TO: All Bidders
FROM: City of Cambridge
DATE: June 24, 2013
RE: File No. 6132 – Solomons Transportation Center Roof Replacement - Addendum No. 1

ADDENDUM NO. 1

PROJECT: Roof Replacement Project
Solomons Transportation Center
Cambridge, Massachusetts
RBA Project No.: 2013020.00

DATE: June 20, 2013

5 OVERFLOW ROOF DRAIN DETAIL
 R-4 N.T.S.

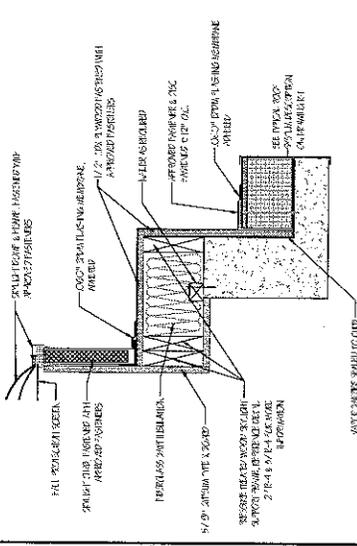
Section 15400, paragraph 2.01; add:

I. Overflow drain piping termination outboard of the exterior brick masonry wall shall be cast bronze downspout nozzle, loose wall flange and inlet threaded connection such as series 25010 by Josam, 1775 by JR Smith or 3940 by Wade.
